RE: Draft Plan of Subdivision: Menzie Enclaves
County of Lanark File No. 09-T-23006

FIRST SUBMISSION COMMENTS RESPONSE TO THE MUNICIPALITY OF MISSISSIPPI MILLS

First Submission Comment Letter – Subdivision Application

Re: Draft Plan of Subdivision – 09-T-23006 – Menzie Enclaves Subdivision, Municipality of Mississippi Mills

**Conception Plan as originally
presented with Semi-detached and
some single home units and homes
footprints**

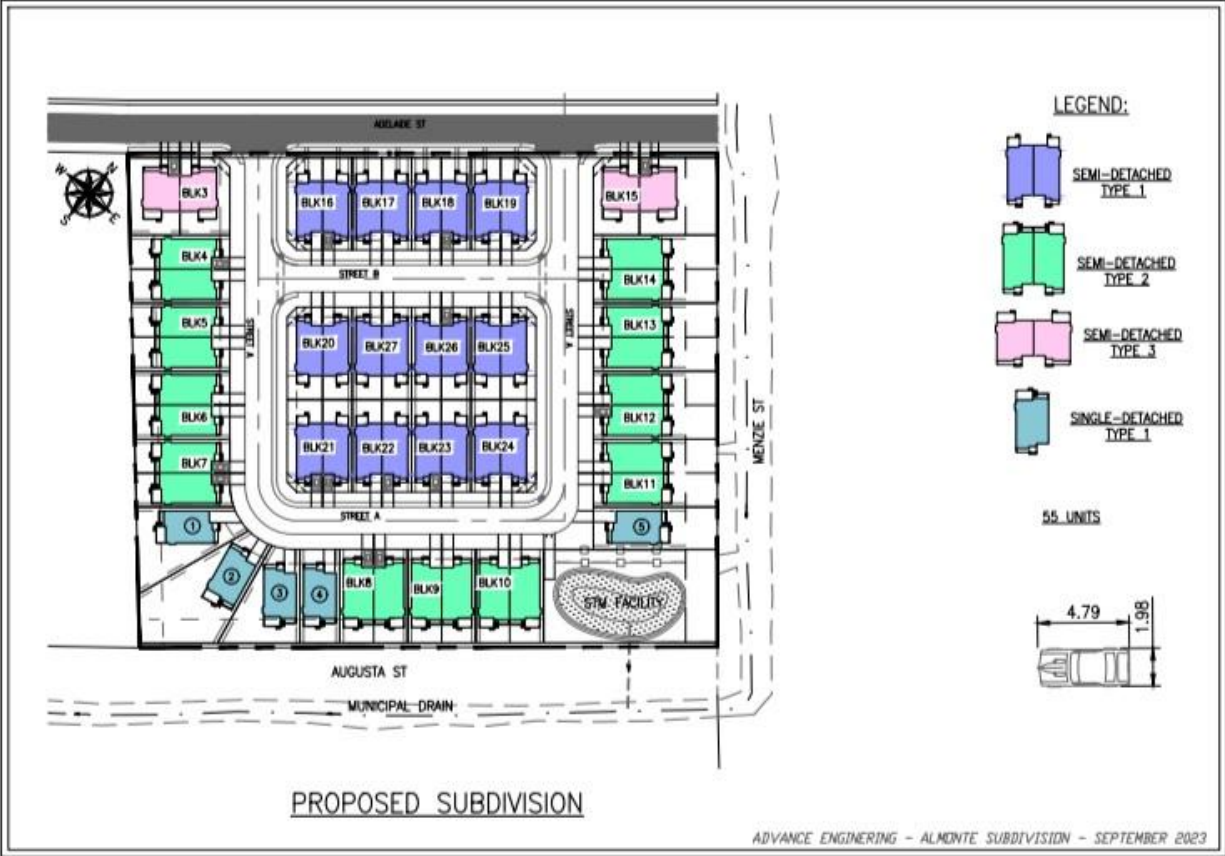
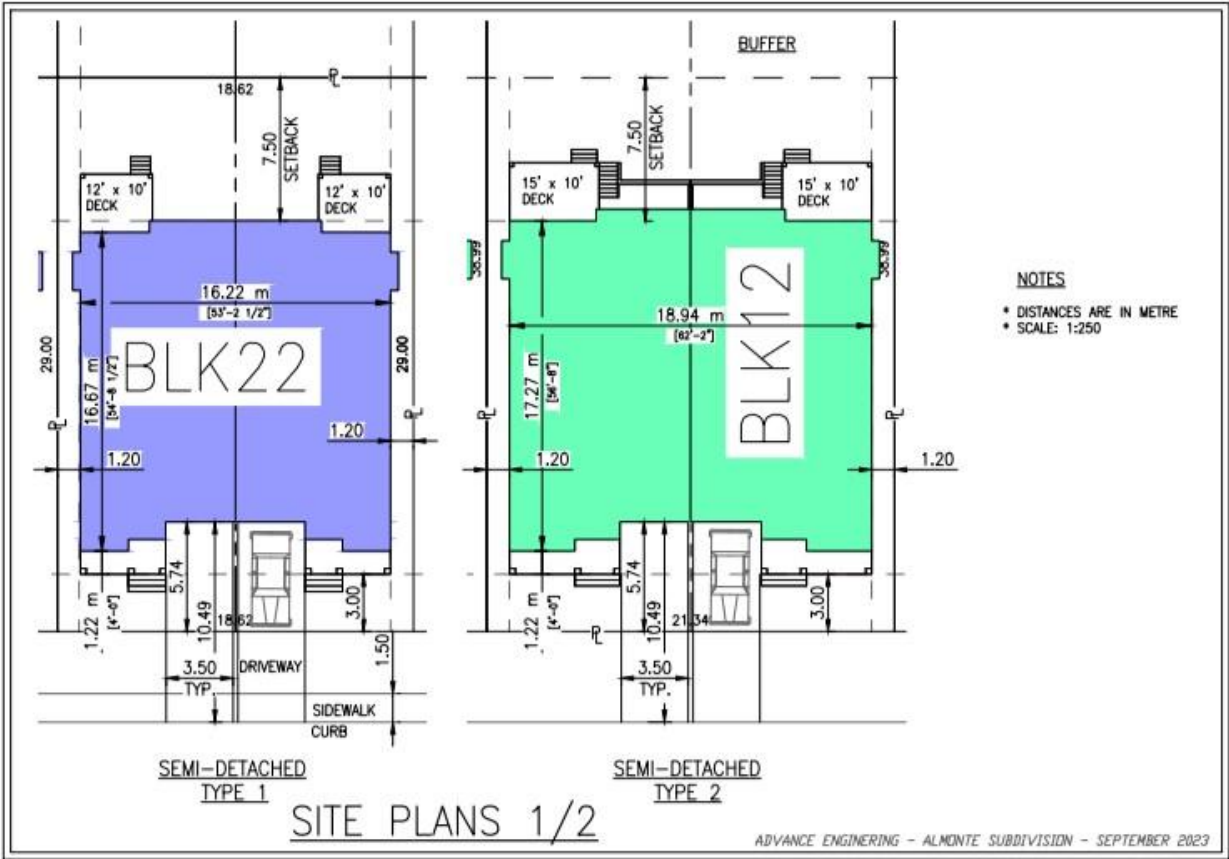
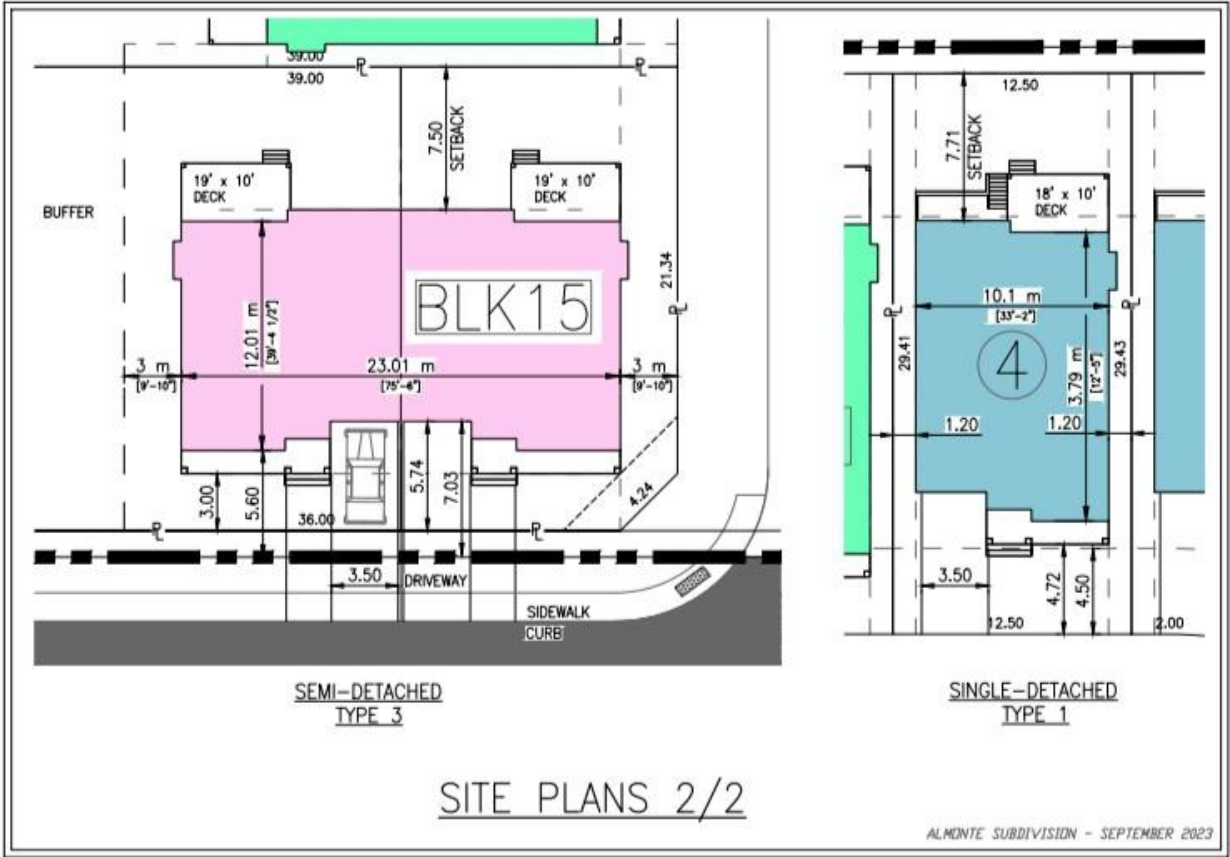
2. Consideration of the design of the lots should incorporate the parking of vehicles on-site, preferably two vehicles per lot (can be in tandem). It appears that the lots that abutting the unopened Menzie road allowance have enough depth to accommodate a greater front yard setback without any structures encroaching into the 10-metre buffer. The Department would appreciate receiving conceptual site plans for each standard type of lot proposed with the proposed building envelopes, fully dimensioned with the Zoning By-law Amendment application to ensure that the proposed lots (and associated zoning) can accommodate an appropriate building envelope as well as on-site parking.

13165647 Canada Inc Response: Conceptual Subdivision plans and plans showing the footprints of proposed house types for each lot type in Addenda II. No elevations shown as the developer wants to develop a plan meeting the character of the Municipality of Mississippi Mills and work with neighboring developments to have uniformity in the subdivision's character.

**Alternative Subdivision Concept Plan
meeting Amendment 22 with higher
density townhouses and homes
footprints**

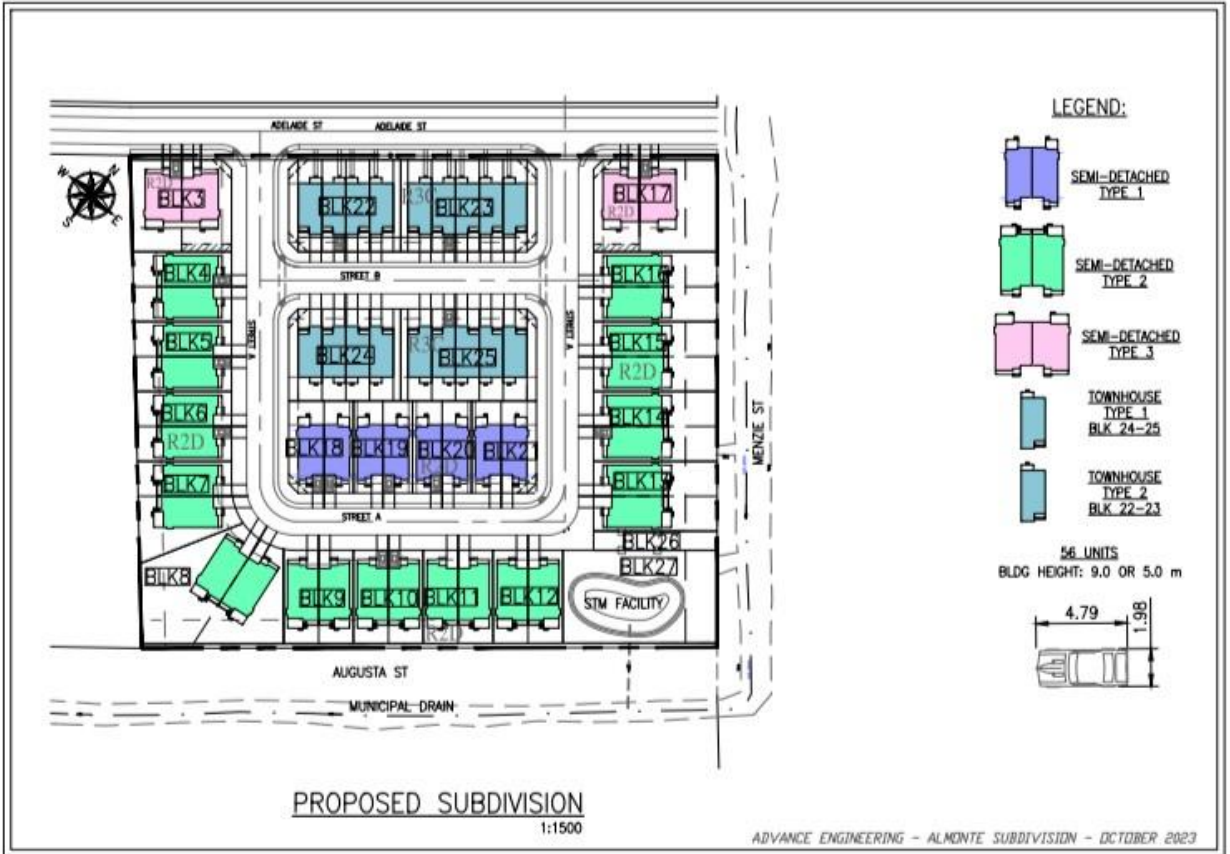
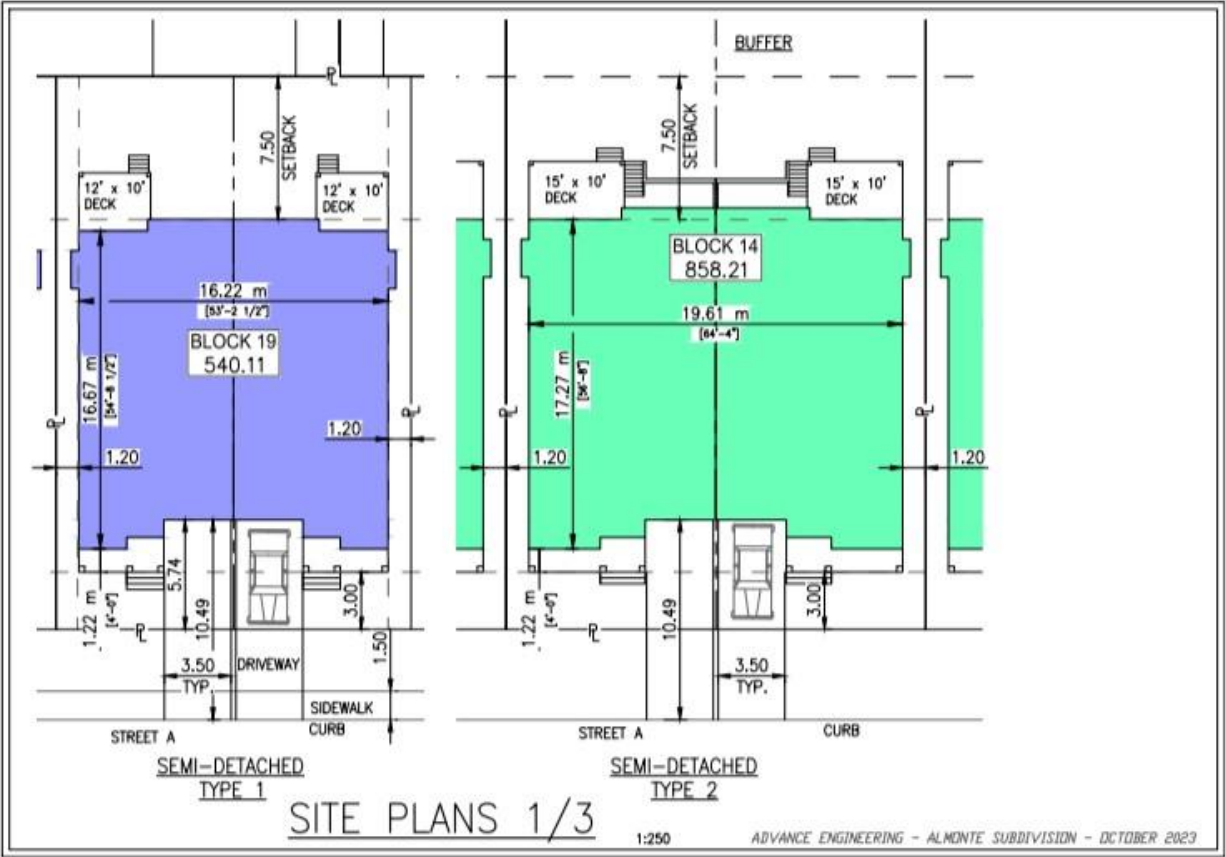
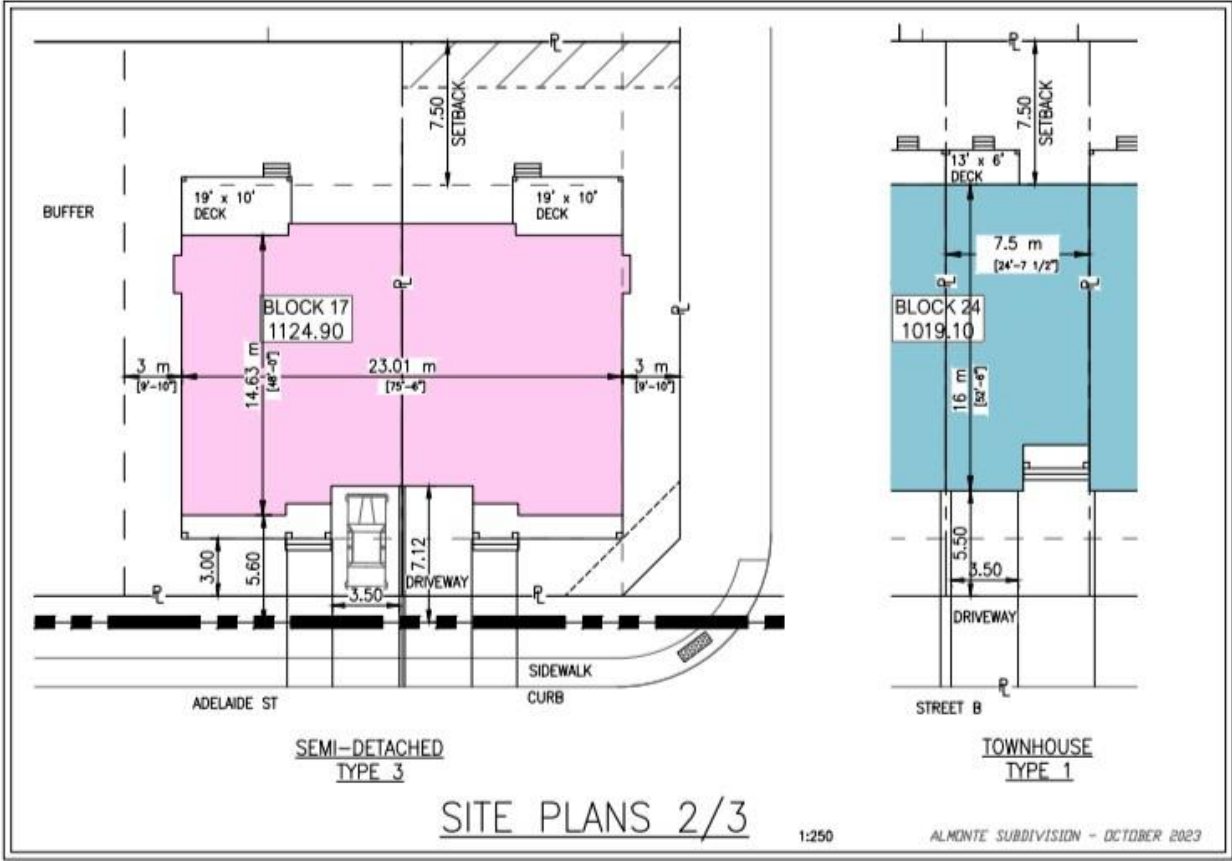
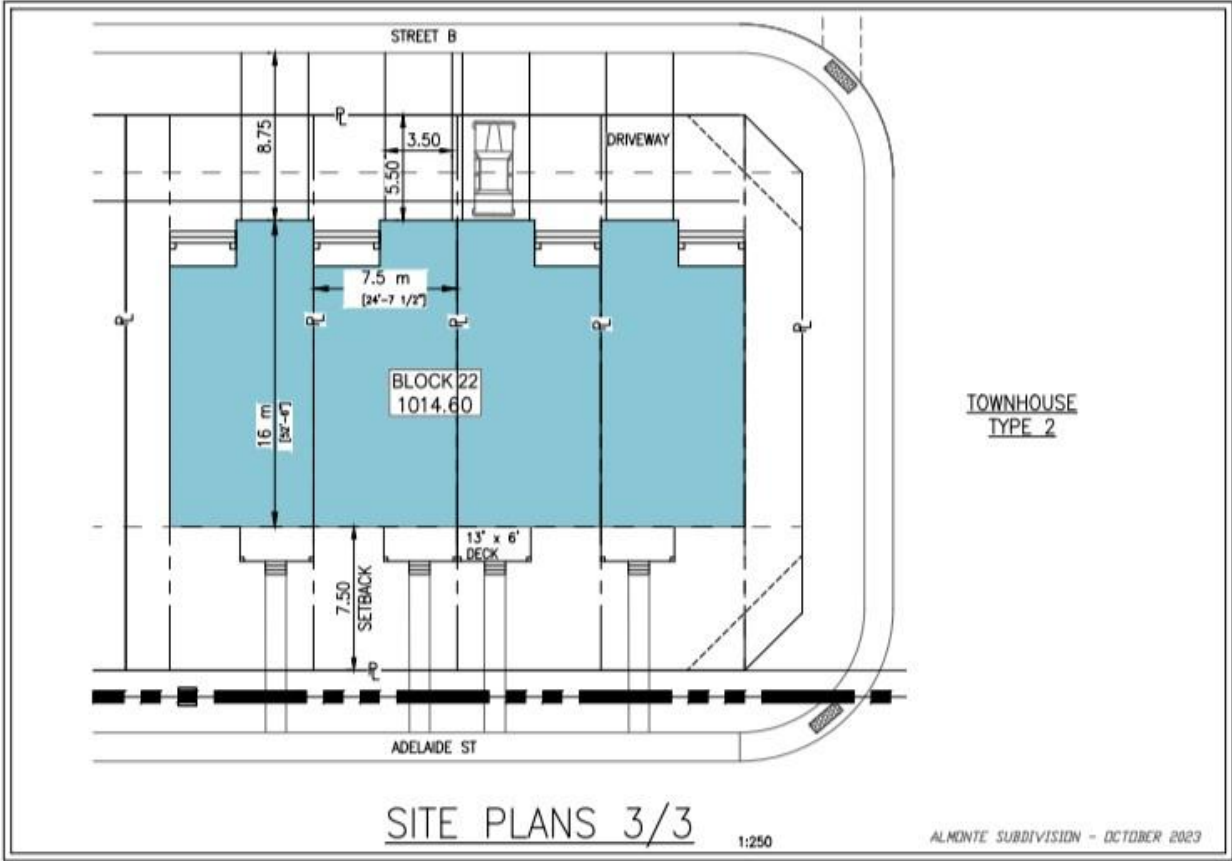
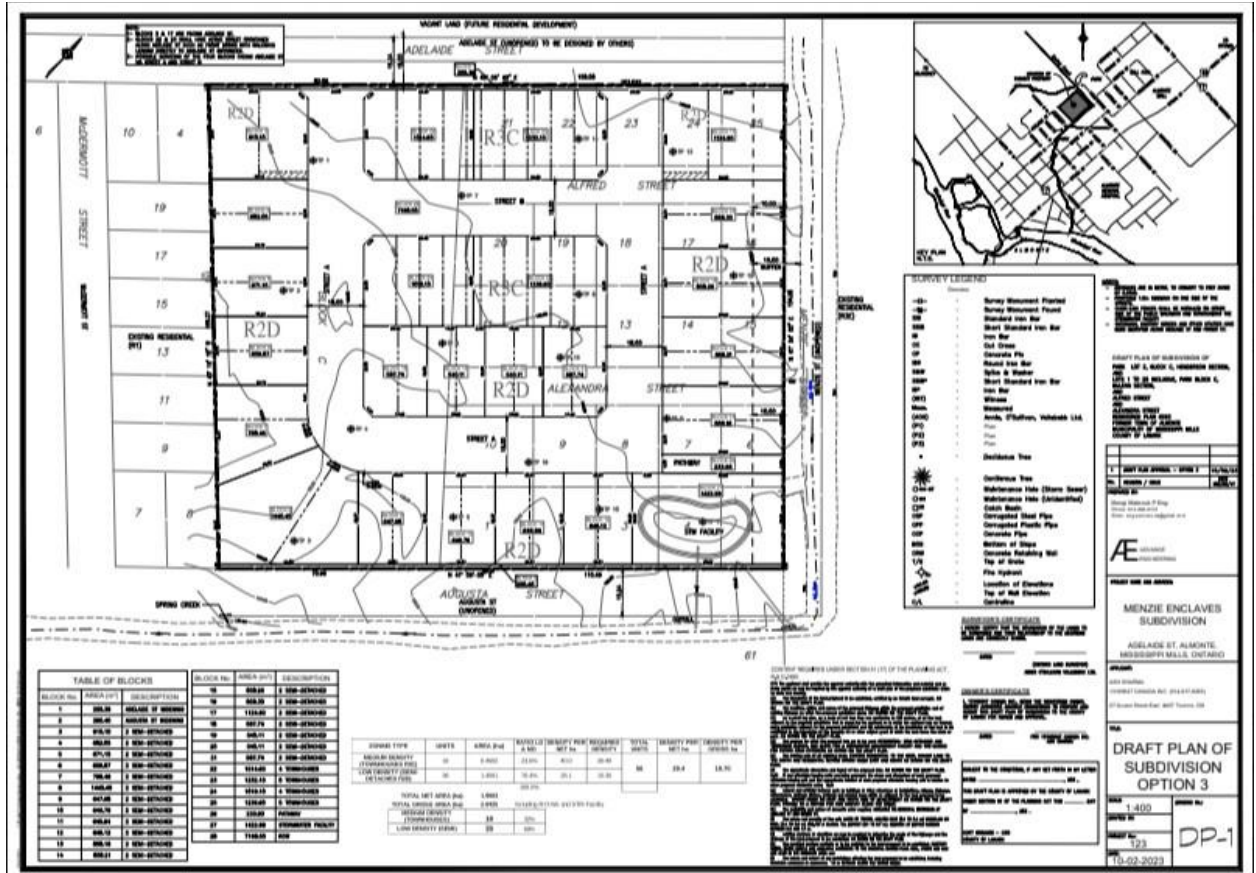
- Correct reference to the Municipality's updated density requirements of 25 units per net hectare and residential split of 60:40 (Low Density Residential to Medium Density Residential) as per the Municipality's approved Official Plan Amendment 22 which can be found here on the Municipality's website:

13165647 Canada Inc Response: When we had a pre –consultation meeting, we actually came with a full impression that our subdivision concept with mostly semi-detached homes was accepted. And we would like that the project is accepted as per the subdivision concept plan in Addenda II. However, we have made an alternative subdivision concept design incorporating the density as demanded which includes Townhouses. Plan attached in Addenda IV with floor footprints plans.
